***TECHNICAL SPECIFICATIONS
PUBLICATIONS LIST
RECALL CAMPAIGN
SERVICE BULLETIN INDEX***

**328 / 328
GTB / GTS**

Ferrari Servizio Assistenza Tecnica

FERRARI NORTH AMERICA

Fig.7

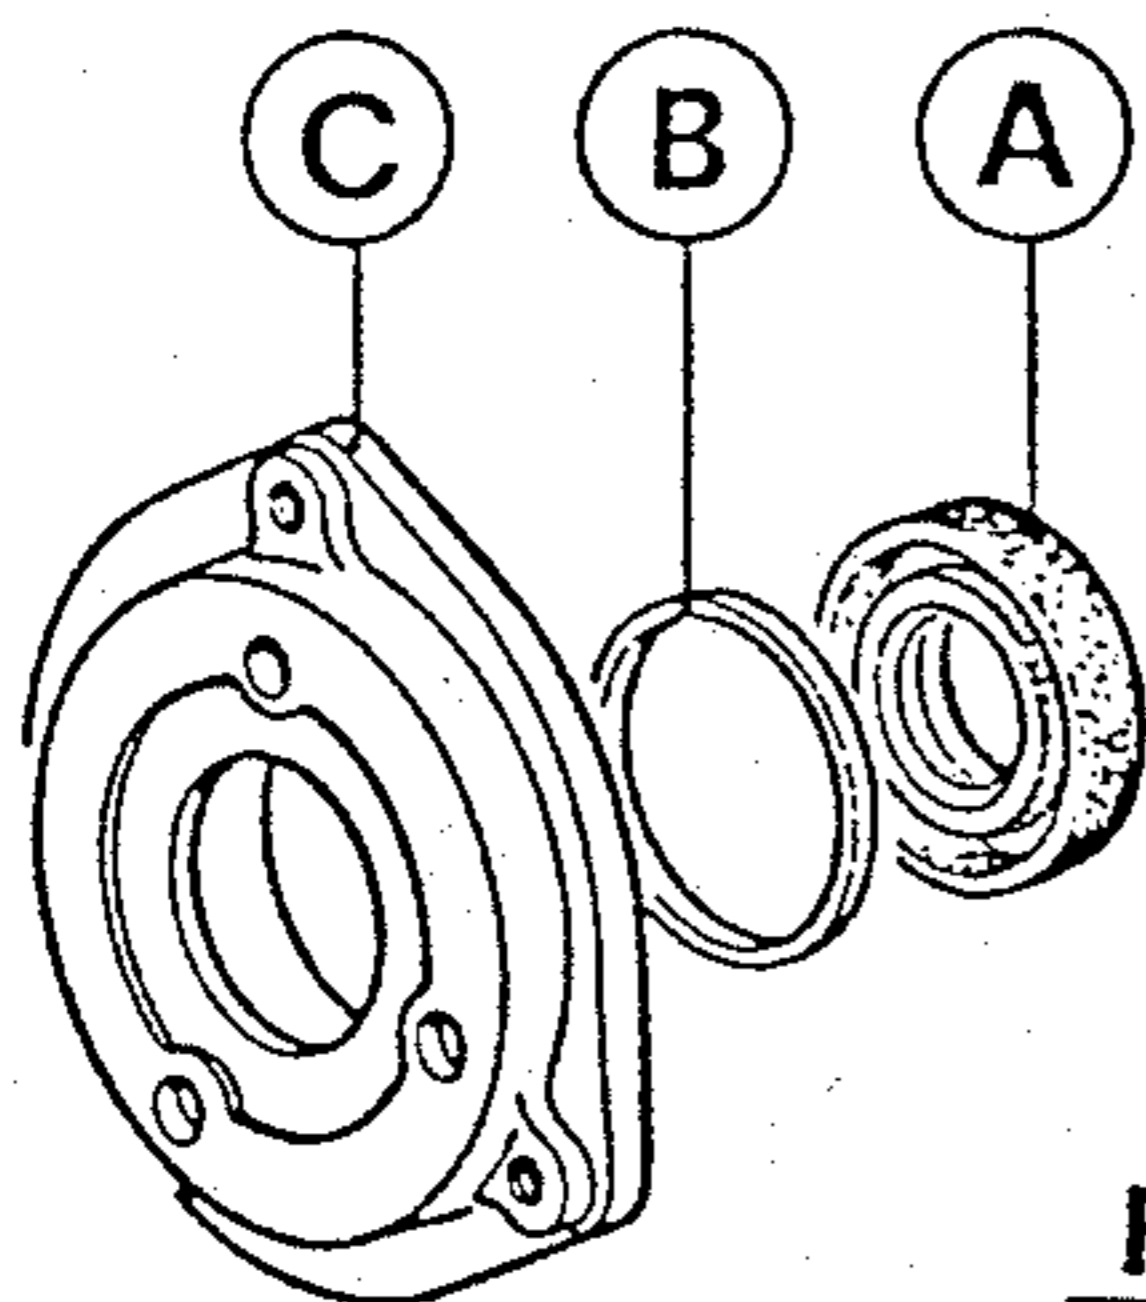
the parts shown by Figure 7 have been introduced into production.

In case of replacement on a previous vehicle, employ only the new seal p.n. 132453, which can be installed on the previous engines with the addition of the 2.25mm spacer (as shown by figure 7), in order to achieve a correct positioning.

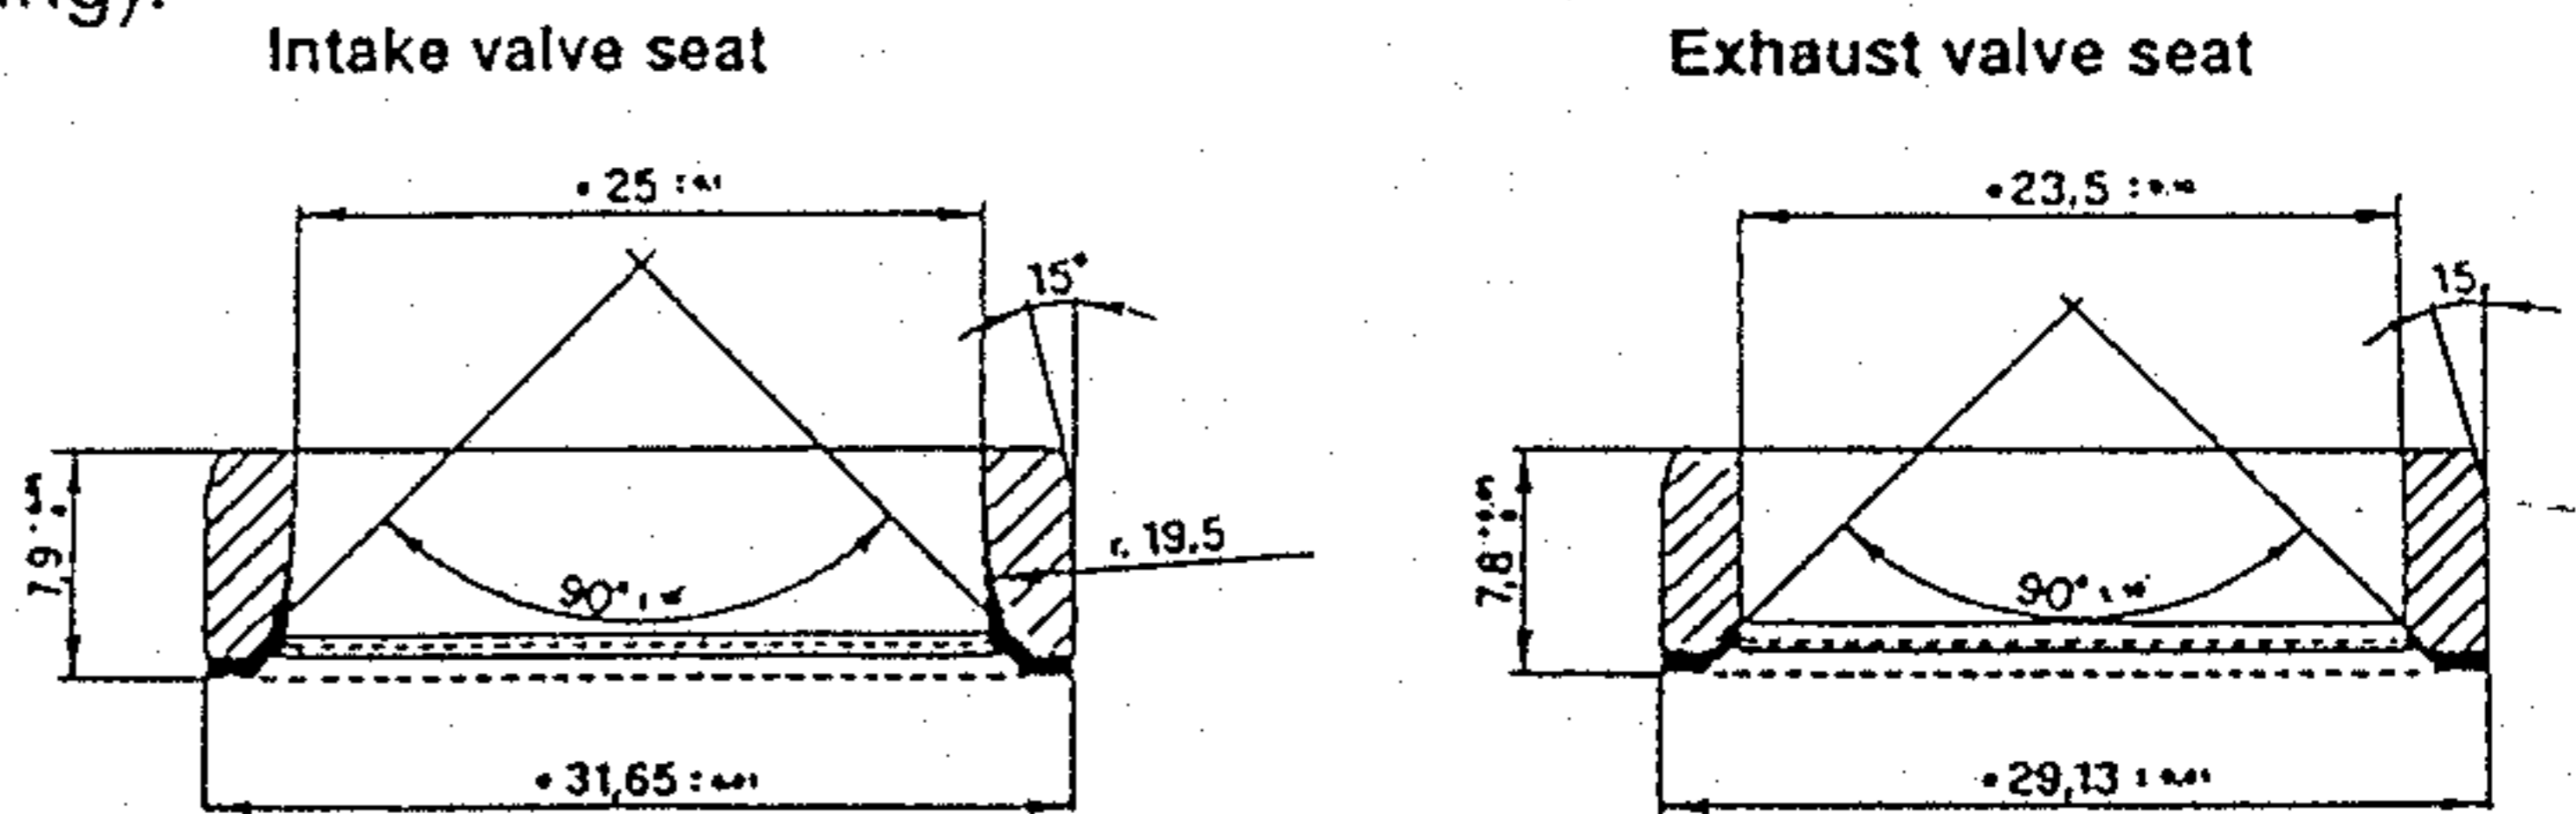
Starting from the above chassis numbers cylindrical instead of conical valve seats have been installed (see drawing).

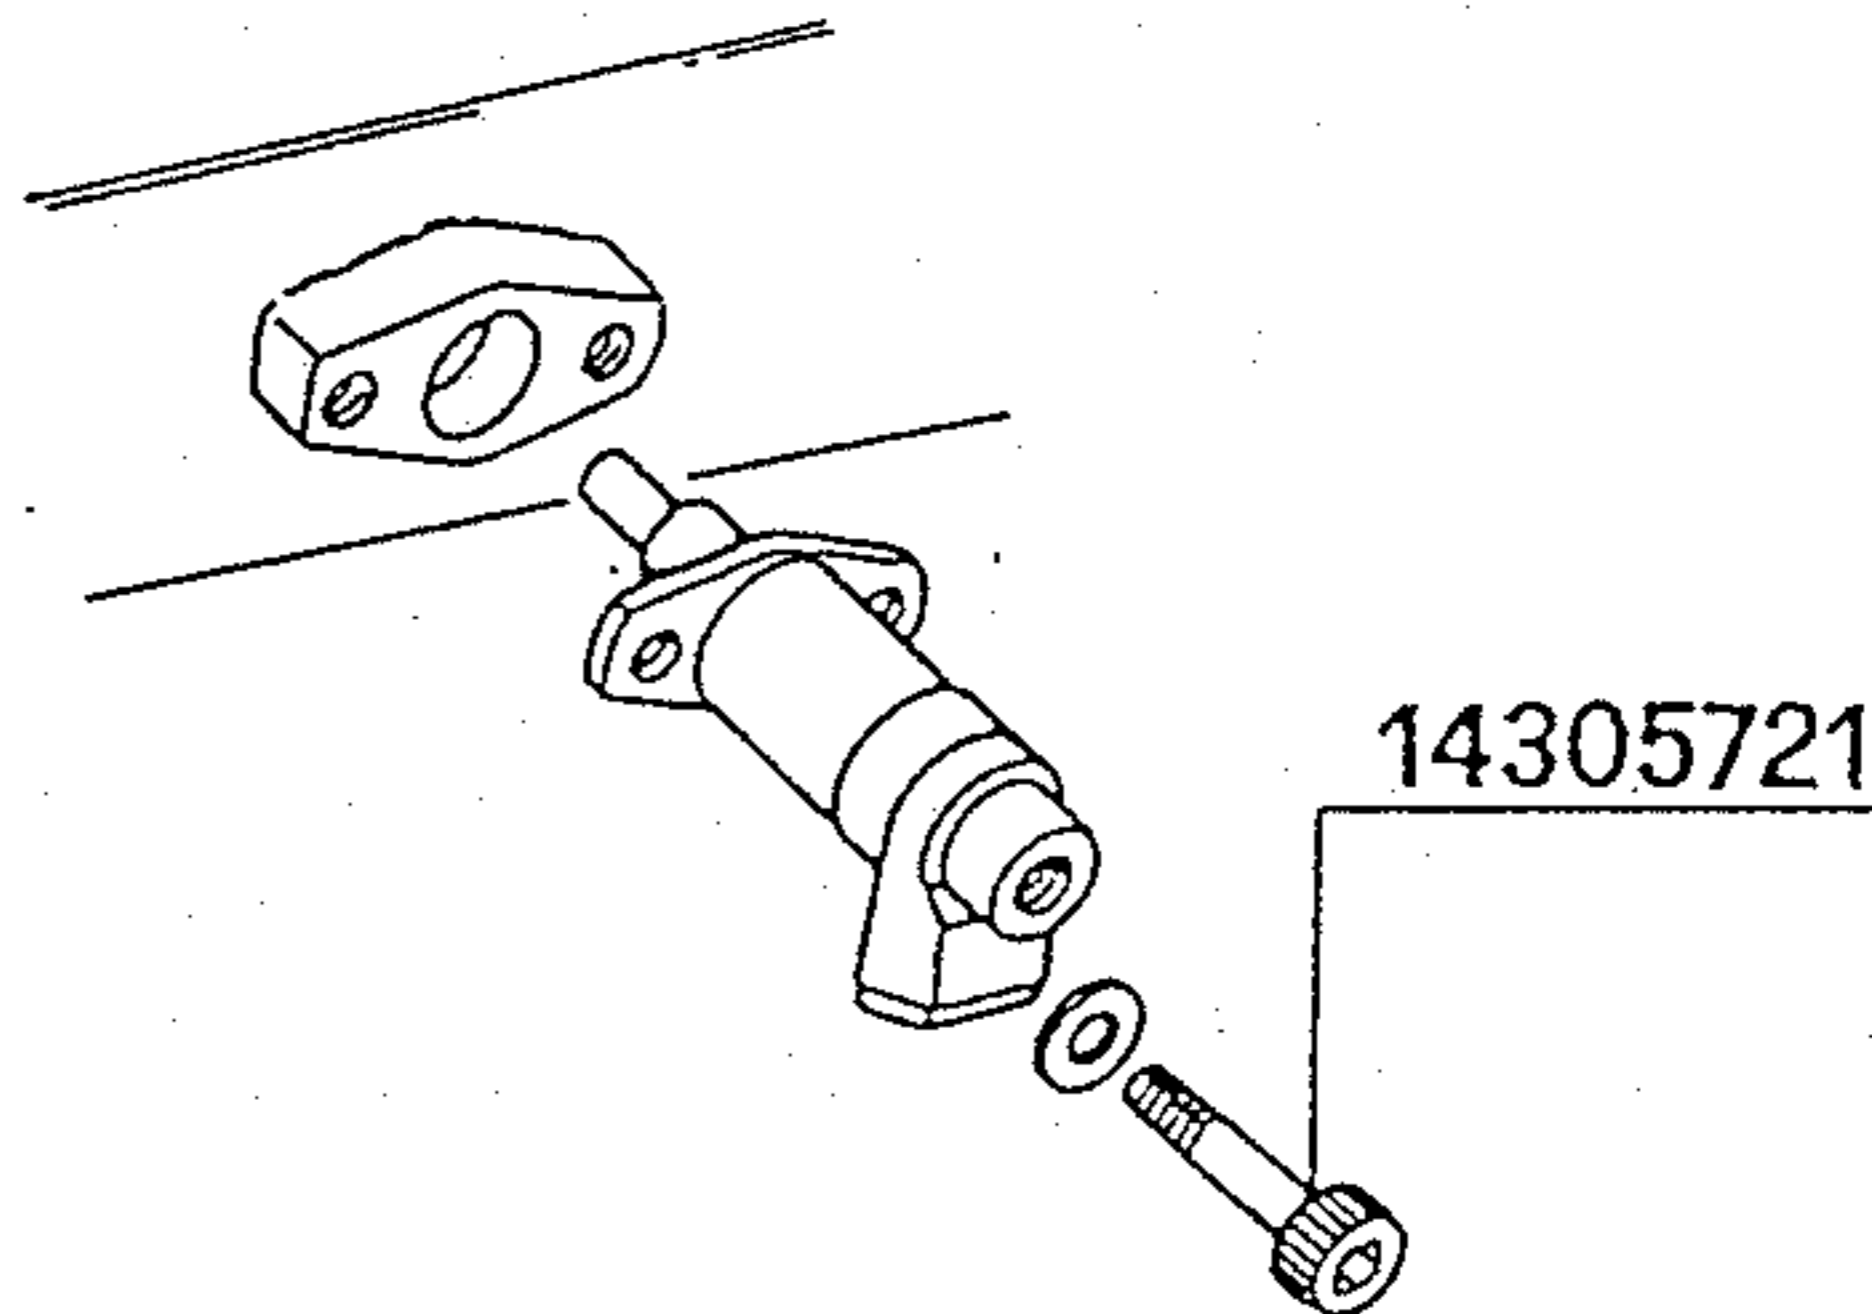
The manner of fastening the cold start injector is no longer accomplished by the use of studs, but rather with socket head cap screws.

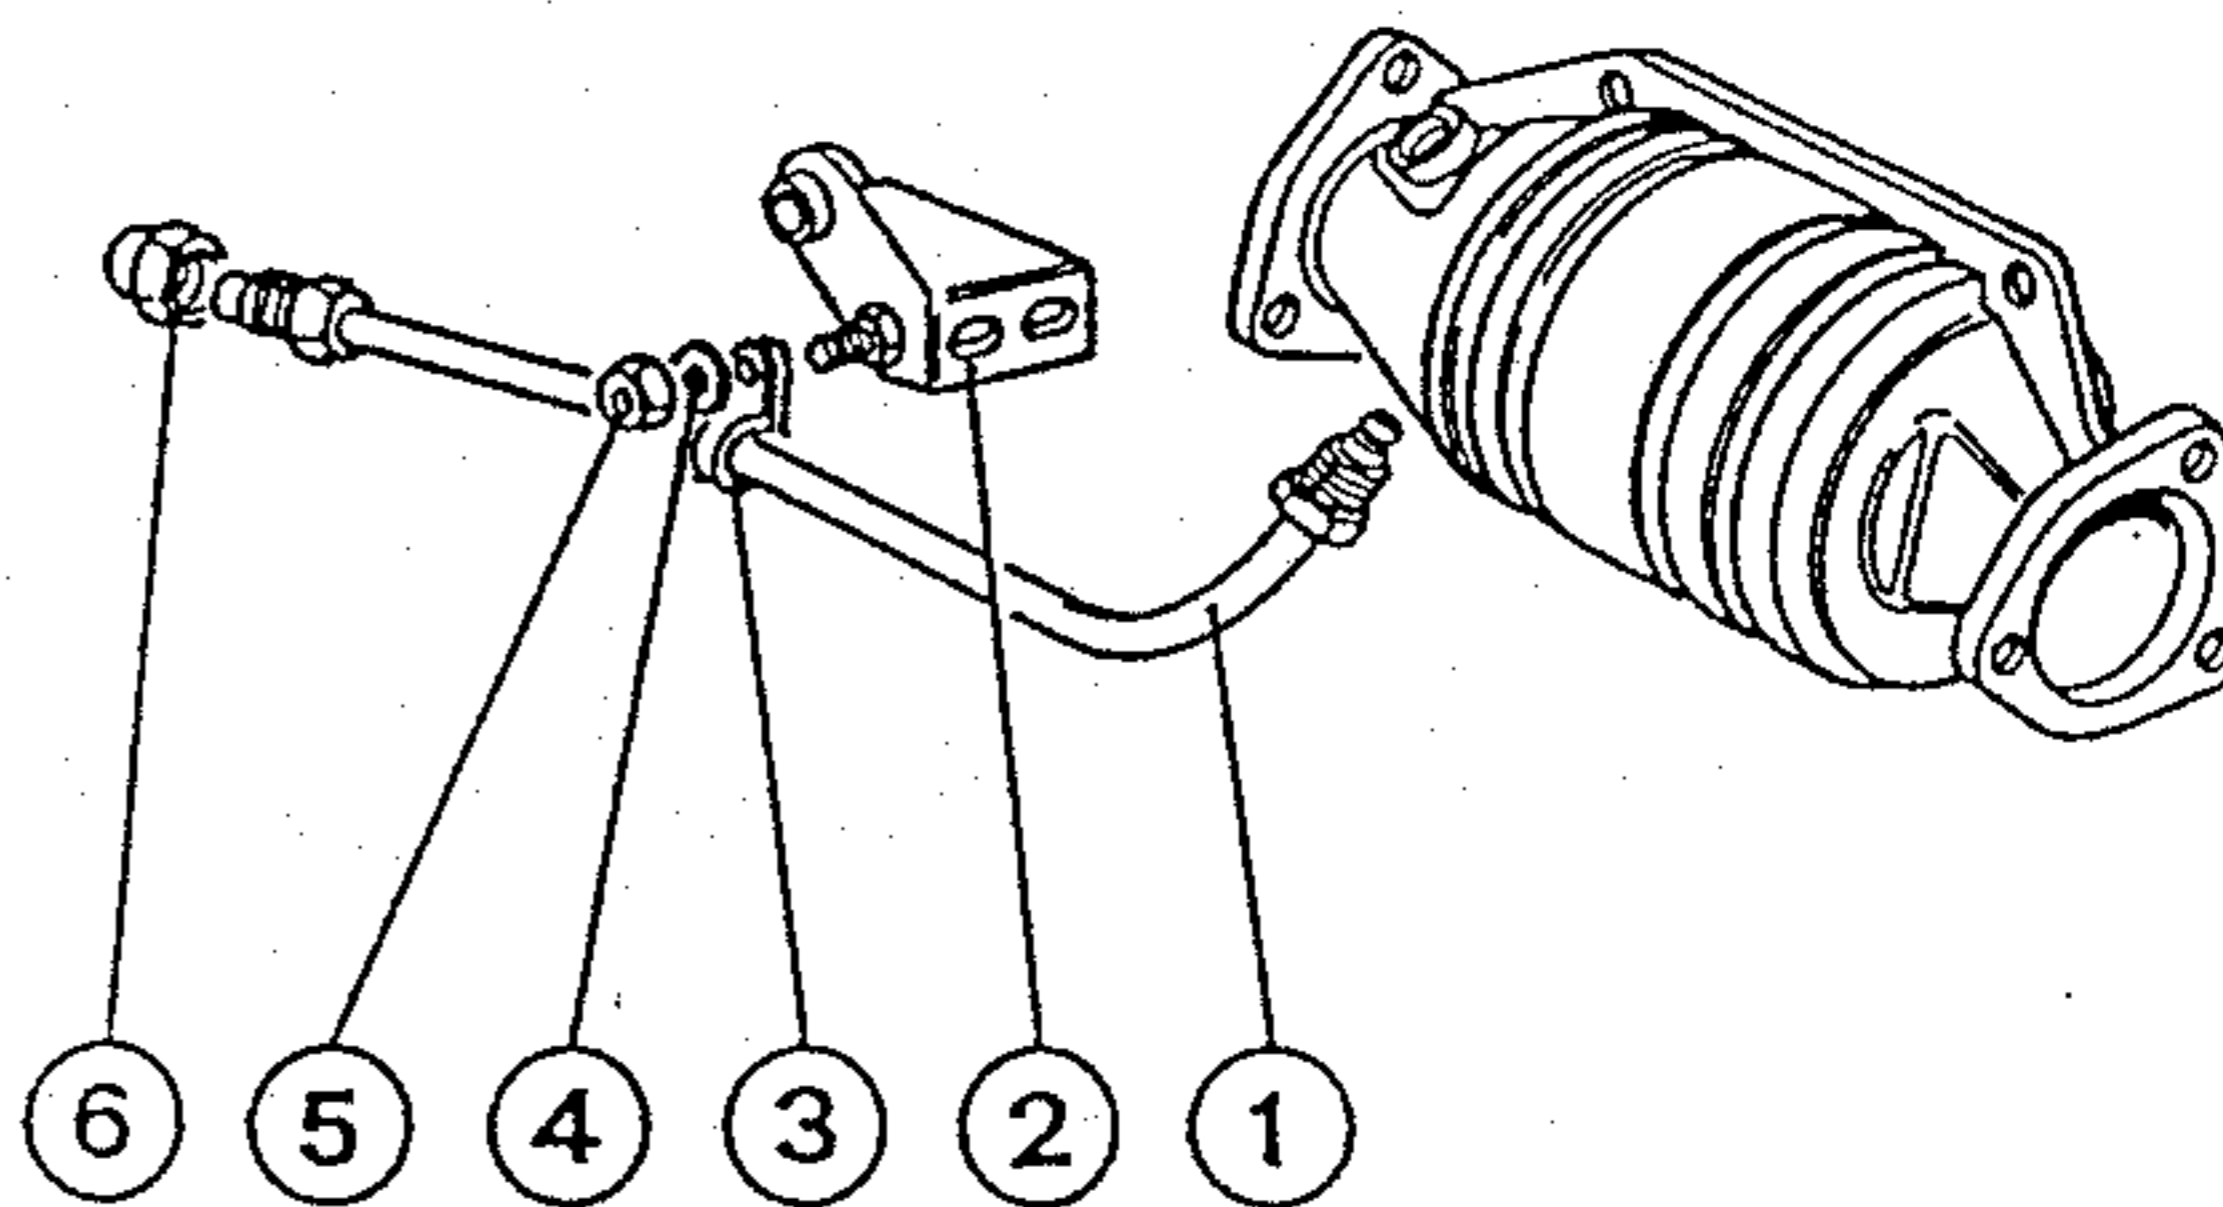
A pipe is installed on the catalytic converter to check CO / HC in order to comply with the new Swiss regulations. The modification is extended on all (8 Cyl.) cars provided with catalytic converters.

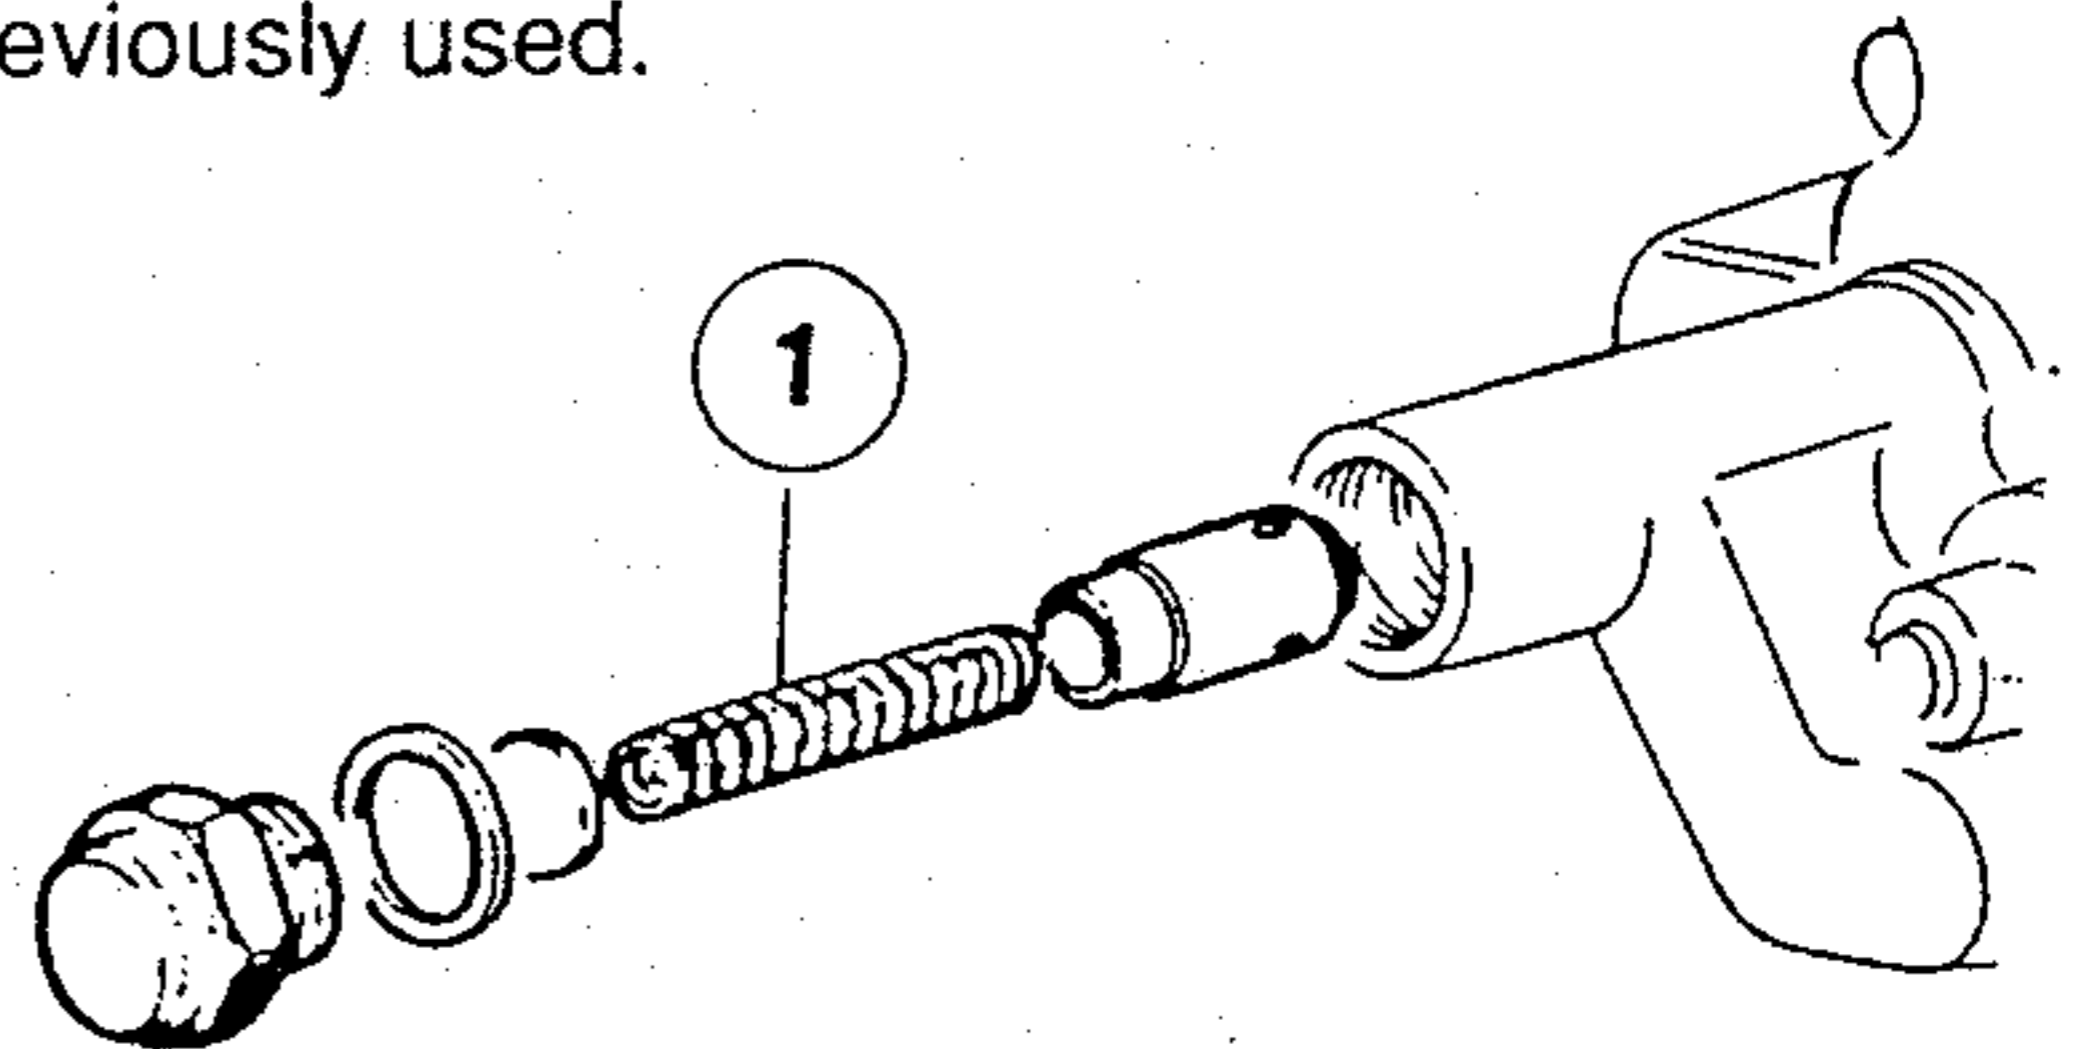
REPLACED PARTS			NEW PARTS		
ref. fig.	Part Number	Description	ref. fig.	Part Number	Description
1	106900	Spring (76 mm long)	1	133550	Spring (72mm long)
